Subject: **WATR 2007o – Bunche Park Water Main Replacement Project**
Notice of Change of Conditions

**RE: Notice of Change of Conditions
City of North Miami Beach – Bunche Park Water Main Replacement Project
Project No. 24-016-SG**

We have now quantified the change of conditions to include 6 different changes quantified below.

DATE: 1/18/2024
 DRAWING NO.: PM-8

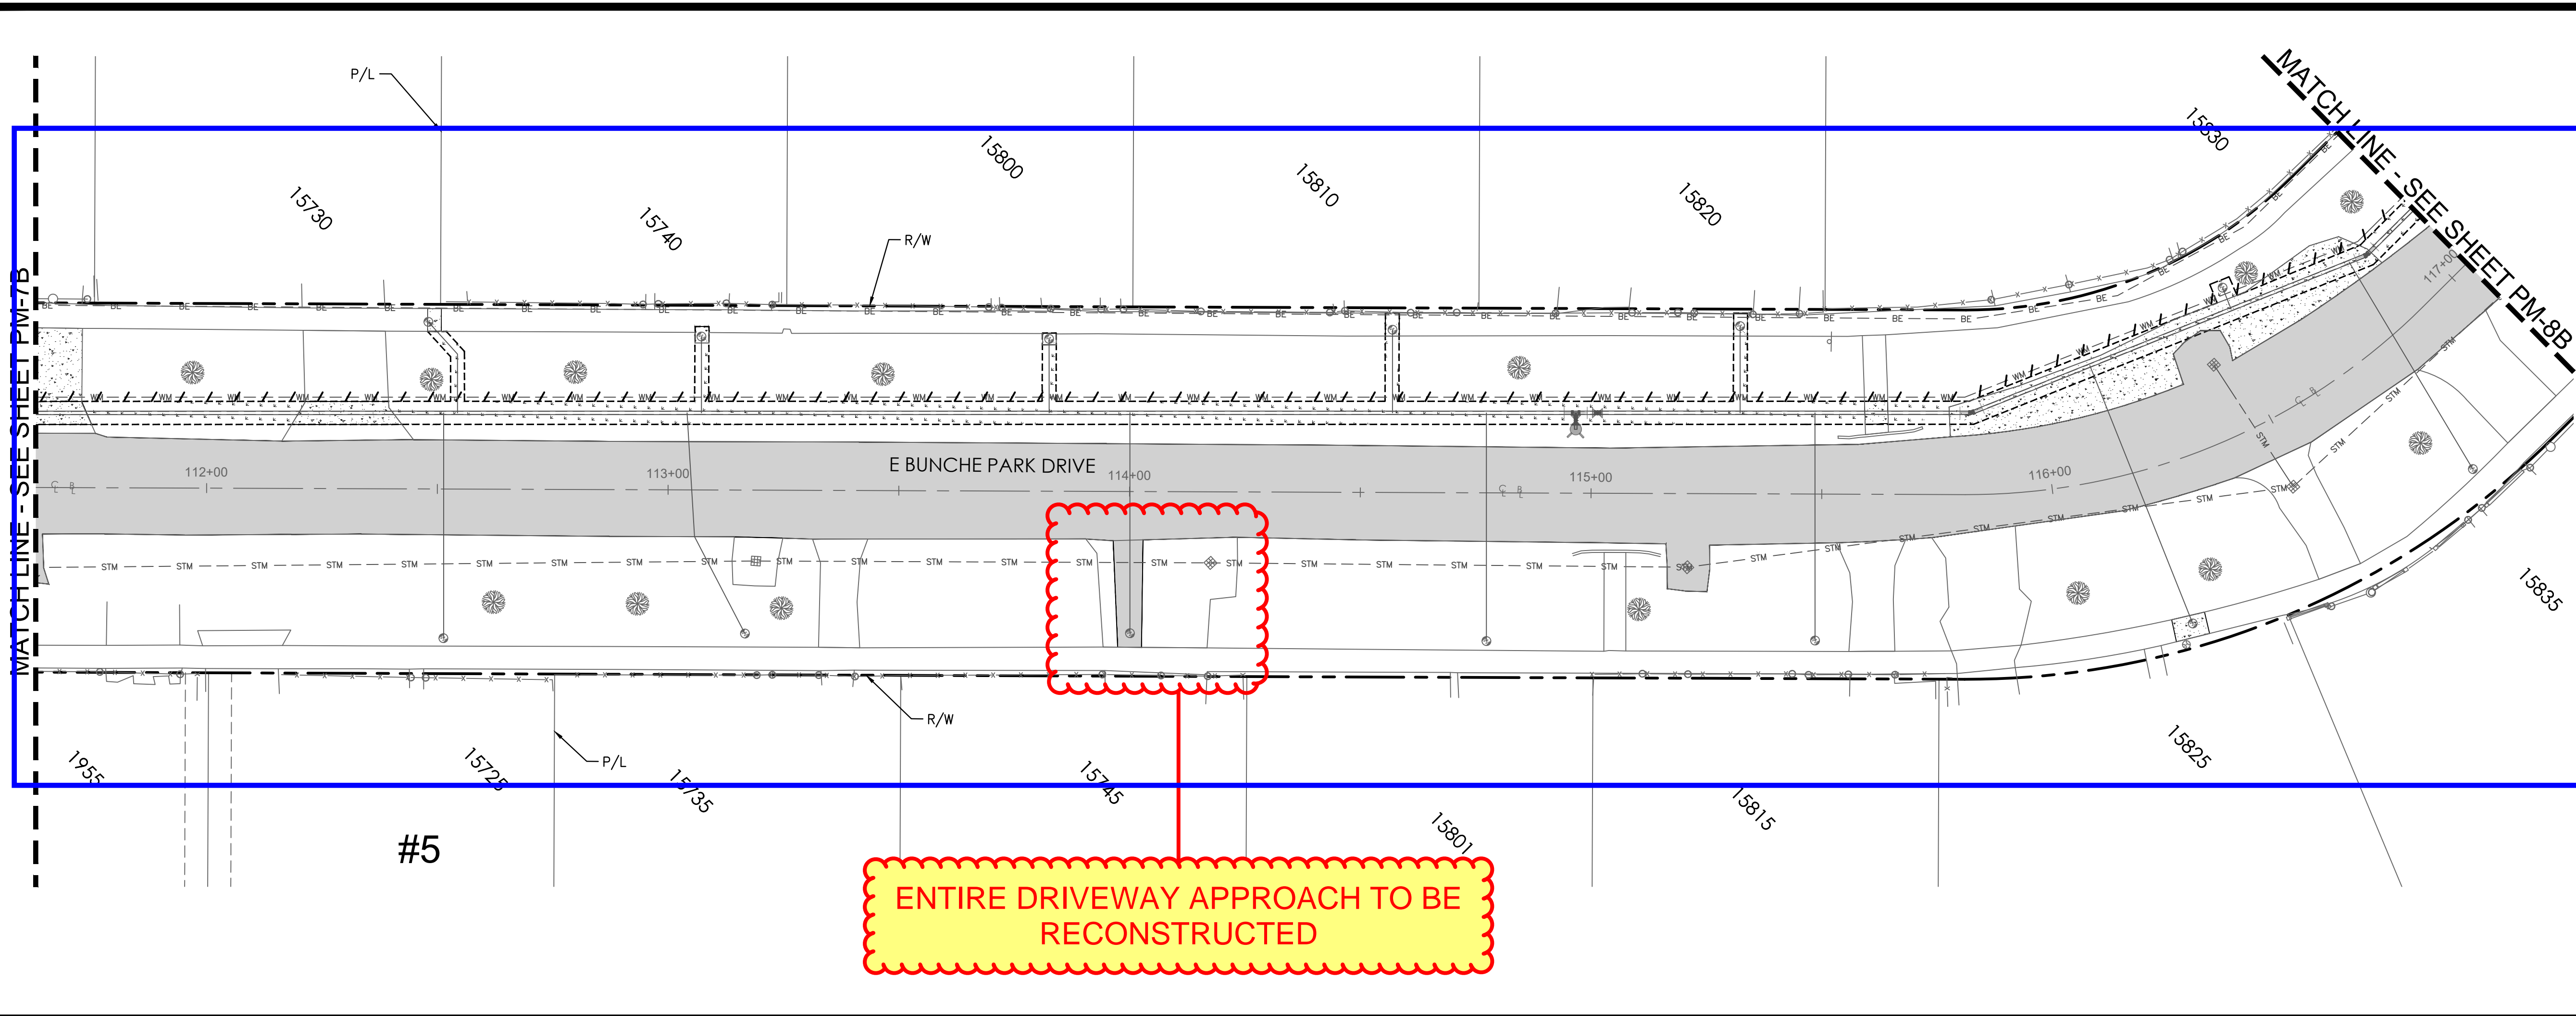
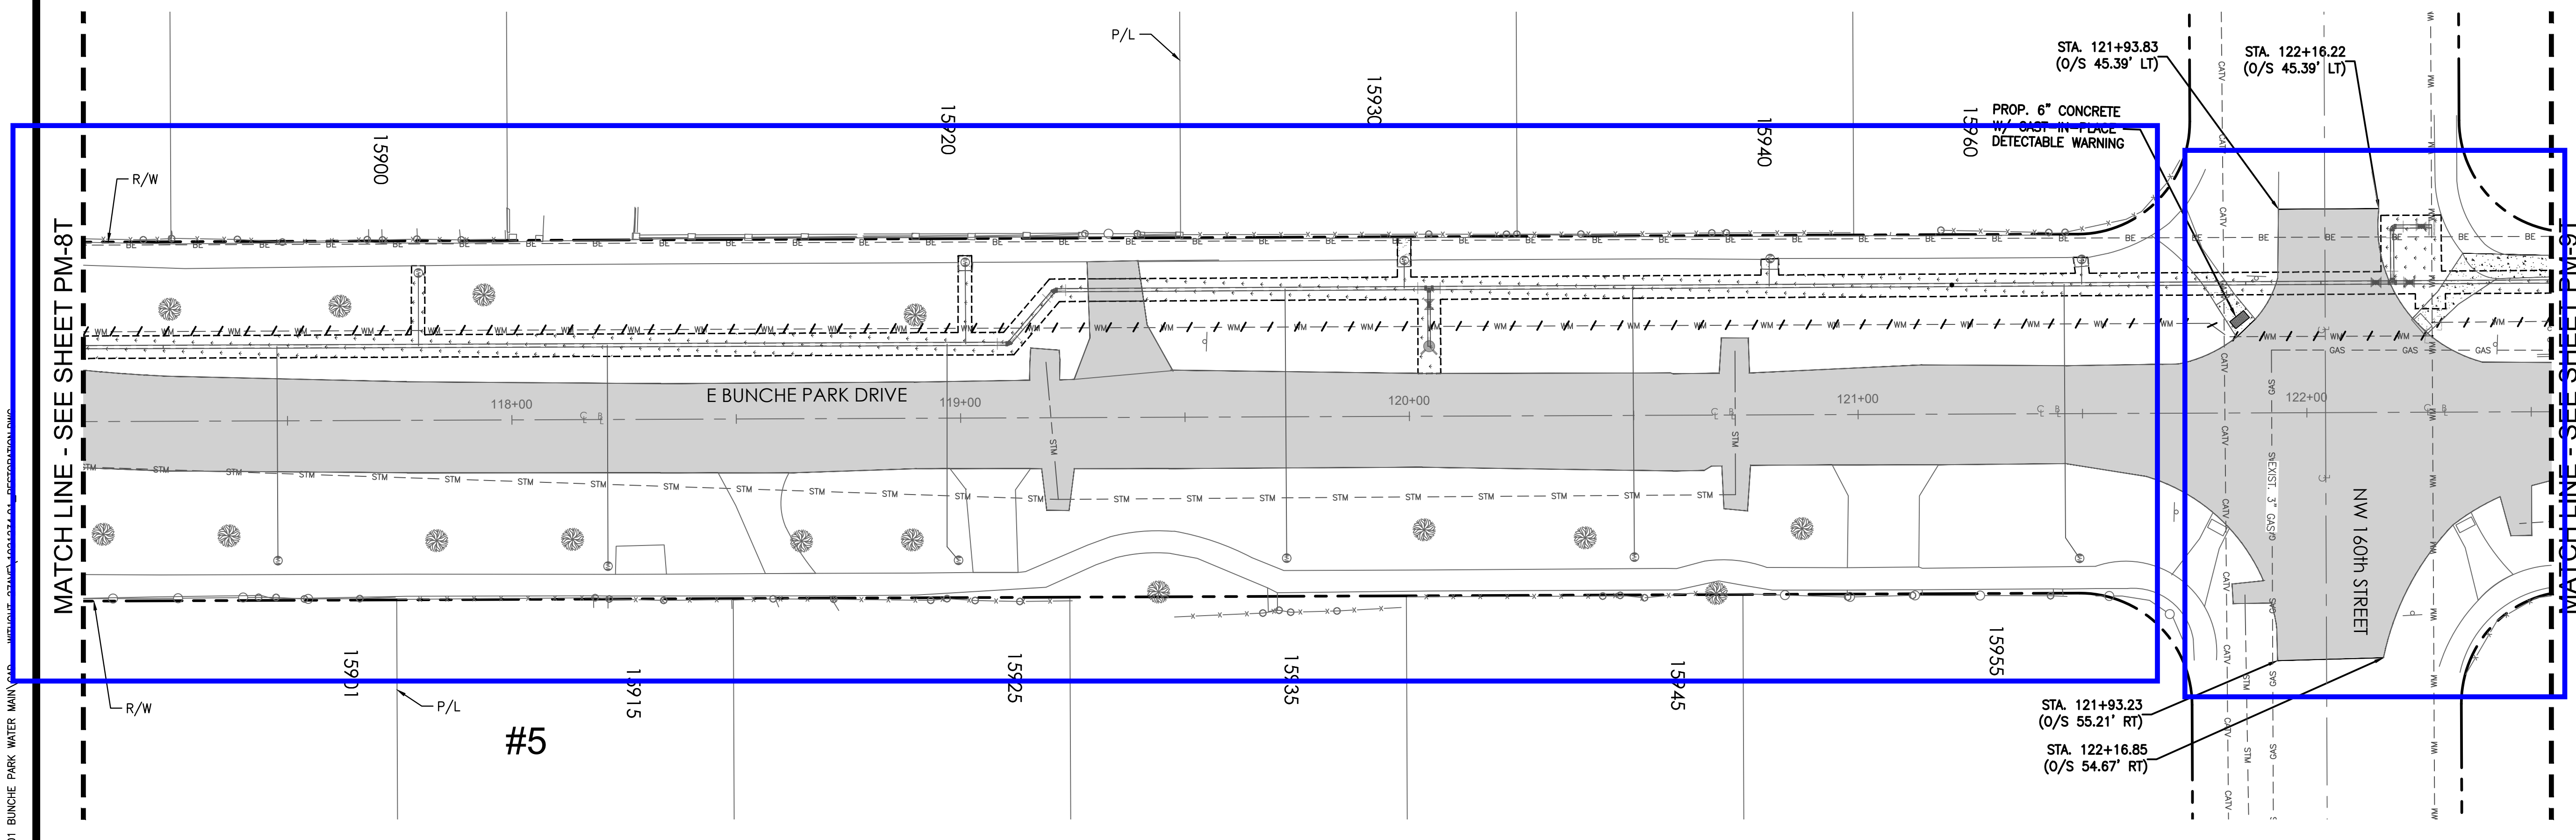
Additional Mill and Overlay Quantities #5									
	Start Station	Stop Station	Page	Total LF	Width	Total SY	Mill \$ (\$3/SY)	Asphalt Overlay (\$14/SY)	Total \$
Bid Spec	0	0	PM-8	0	0	0	\$0.00	\$0.00	\$0.00
MG Spec	111+85	121+69	PM-8	984	20	2186.666667	\$6,560.00	\$30,613.33	\$37,173.33
Cost Difference									\$37,173.33

Additional Mill and Overlay Quantities #6									
	Start Station	Stop Station	Page	Total LF	Width	Total SY	Mill \$ (\$3/SY)	Asphalt Overlay (\$14/SY)	Total \$
Bid Spec	121+69	122+38	PM-8	69	15	115	\$345.00	\$1,610.00	\$1,955.00
MG Spec	121+69	122+50	PM-8	81	30	270	\$810.00	\$3,780.00	\$4,590.00
Cost Difference									\$2,635.00

DATE: 1/18/2024
 DRAWING NO.: PM-9

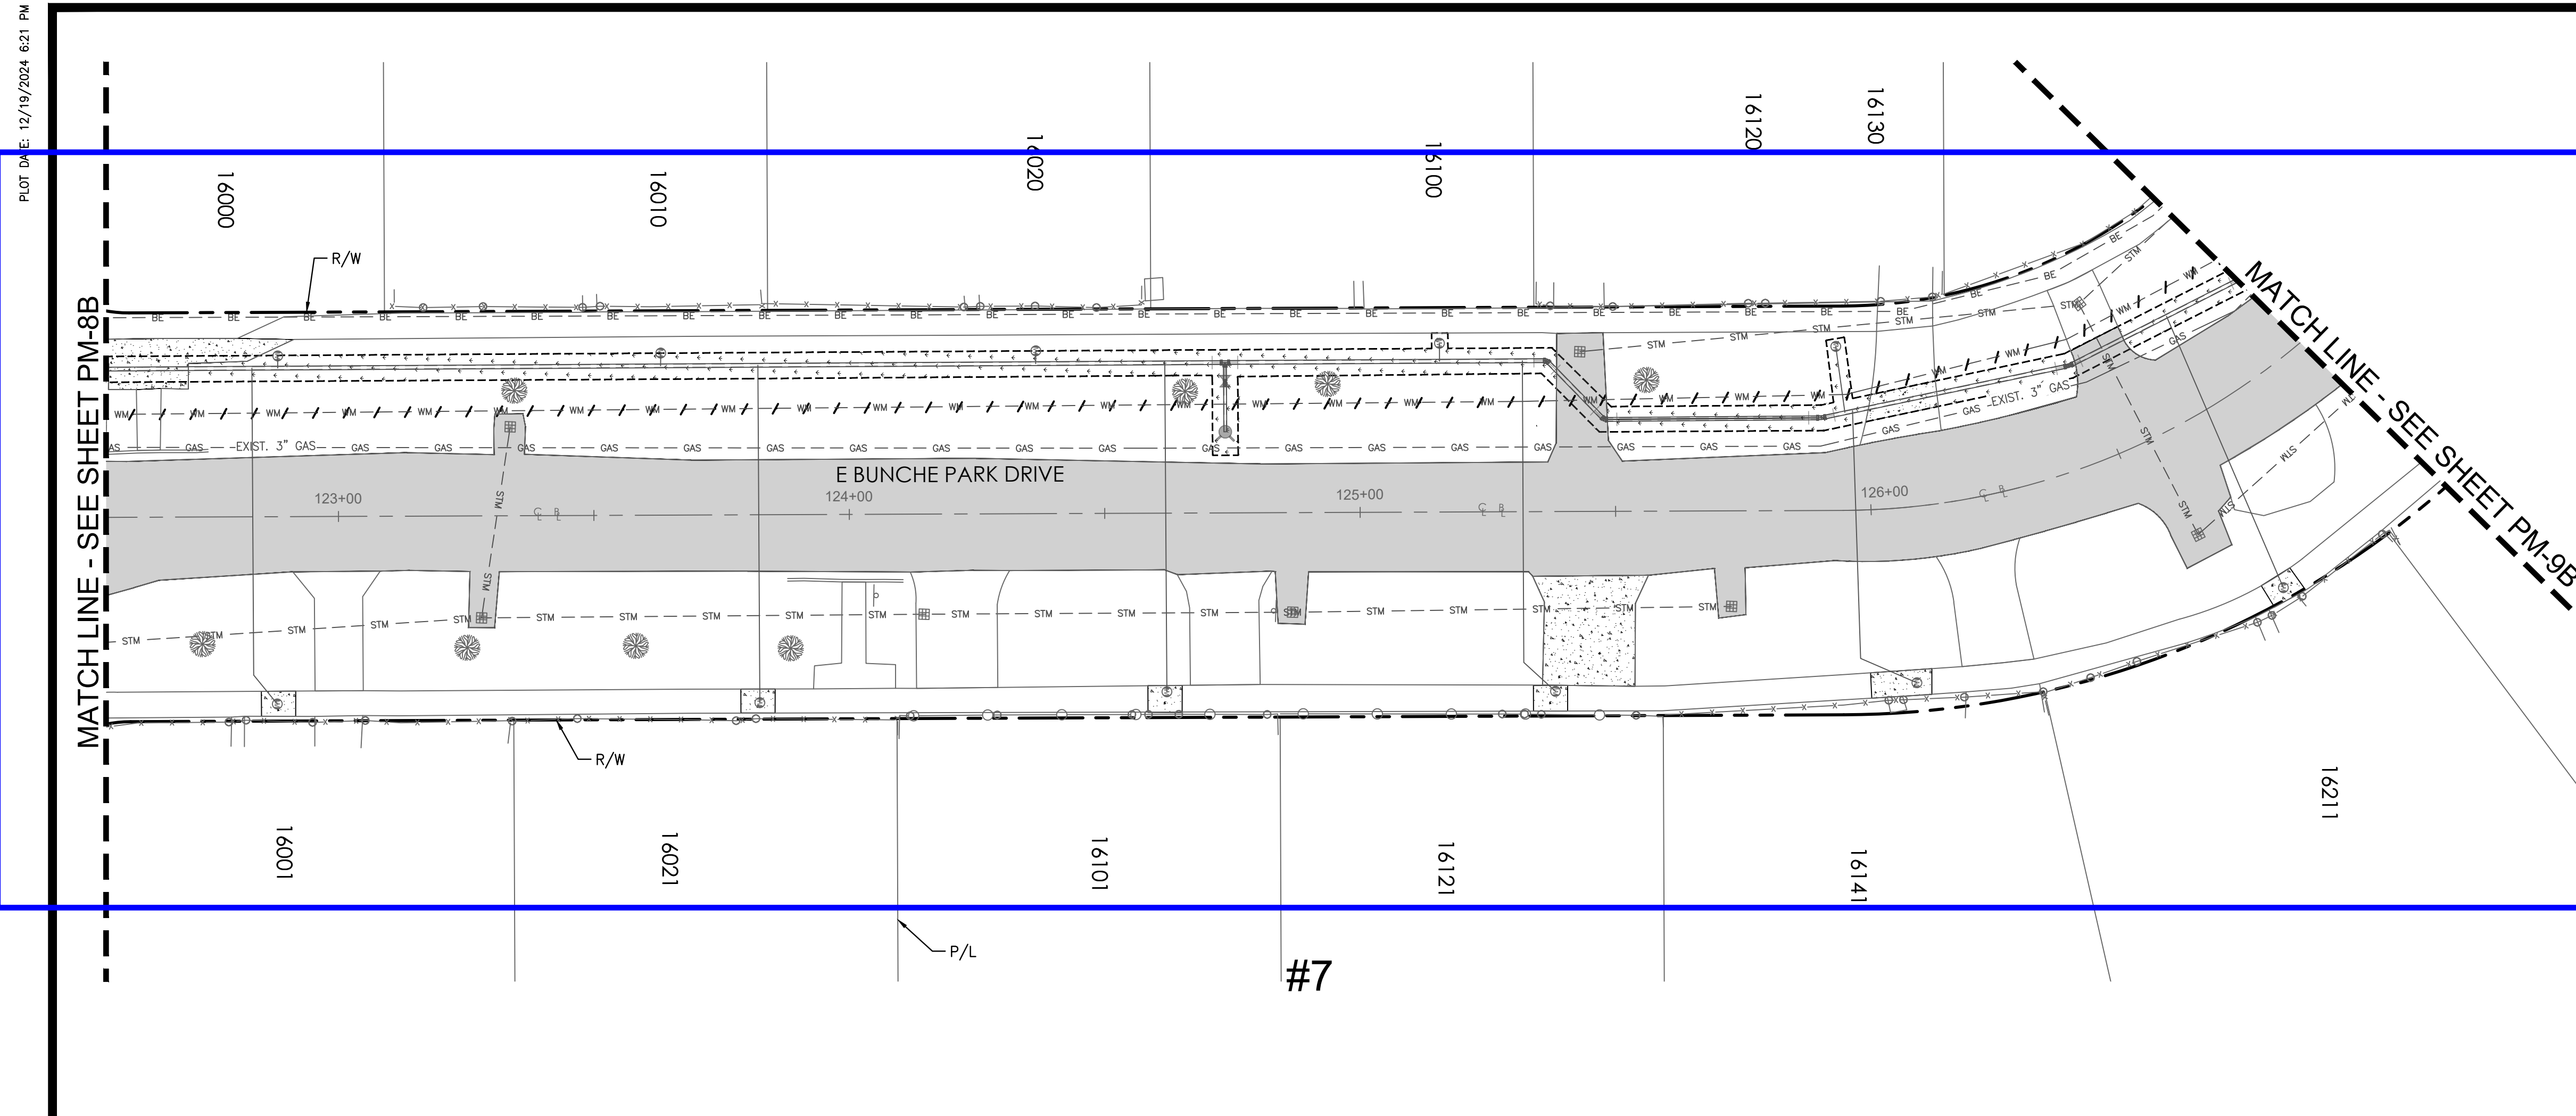
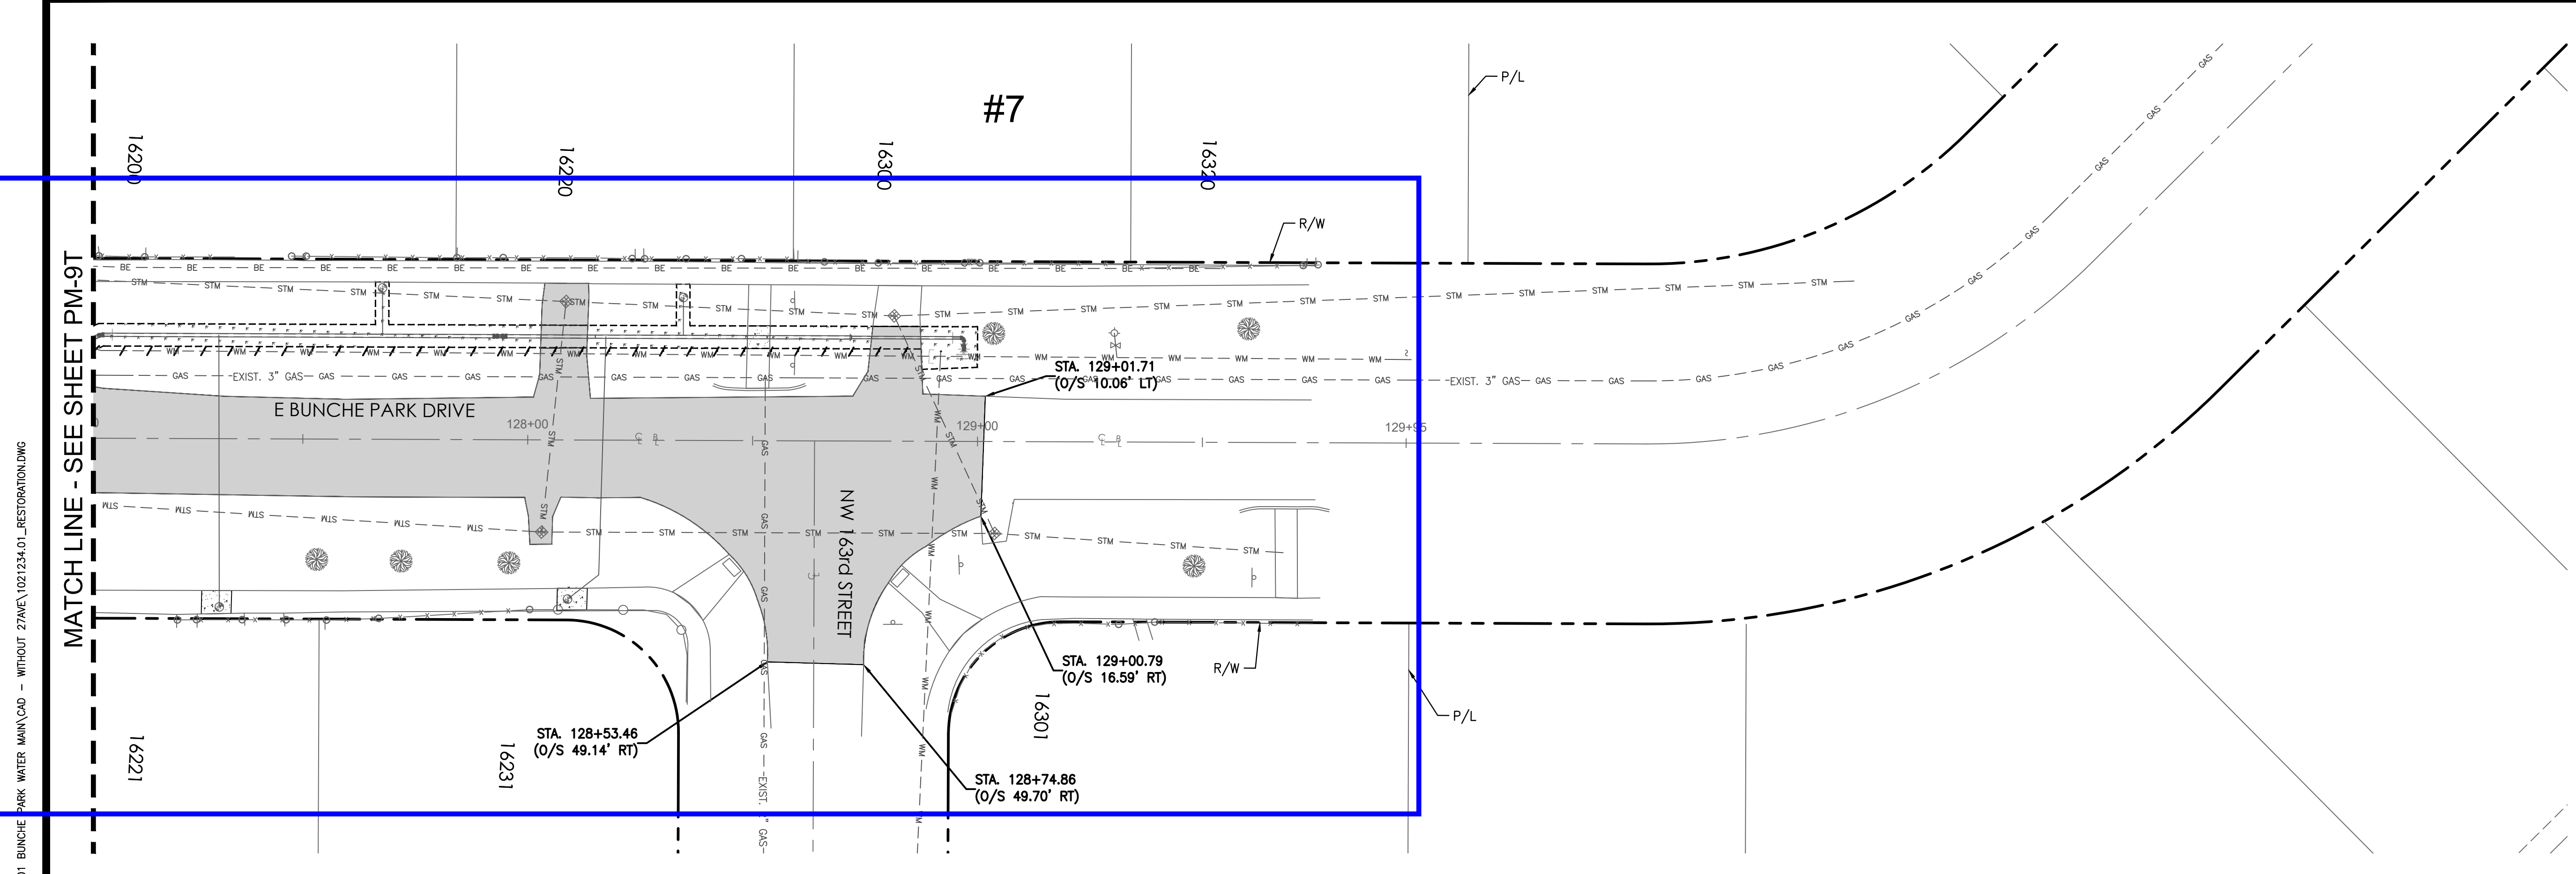
Additional Mill and Overlay Quantities #7									
	Start Station	Stop Station	Page	Total LF	Width	Total SY	Mill \$ (\$3/SY)	Asphalt Overlay (\$14/SY)	Total \$
Bid Spec	0	0	PM-9	0	0	0	\$0.00	\$0.00	\$0.00
MG Spec	122+50	129+02	PM-9	652	20	1448.888889	\$4,346.67	\$20,284.44	\$24,631.11
Cost Difference									\$24,631.11
